**Development Agreement:
1781 King Street, Windsor (PID 45162005) and
PID 45408374, Edward Drive, Garlands Crossing**

Planning Advisory Committee

July 11, 2024

Connection Option 1

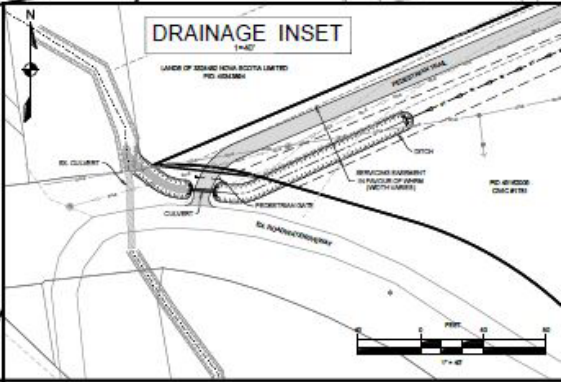
- Irven Drive Extension ending in a cul-de-sac with a 25 ft. wide access easement in favour of the Municipality to provide an emergency access / active transportation connection
- Attached to the draft development agreement
- Due to the reasons mentioned previously (i.e., length of cul-de-sac and Future Streets Map requirements) this option is not recommended by staff

Connection Option 2

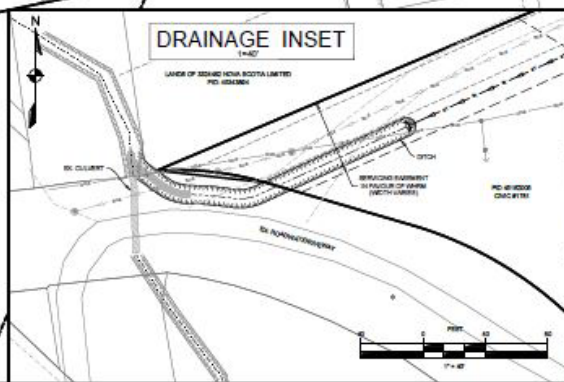
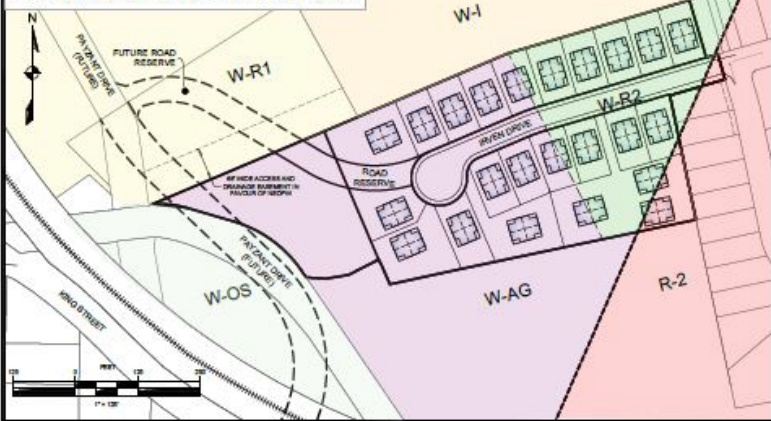
- Irven Drive Extension ending in a cul-de-sac with a road reserve being provided, angled towards the abutting private property to the north west
- Applicant suggests that the two private property owners could provide land to allow the road reserve to connect the future Irven Drive Extension to the future Payzant Drive Extension
- Unless there is agreement from both property owners to provide the road reserve as depicted on the plan it would not be a feasible option
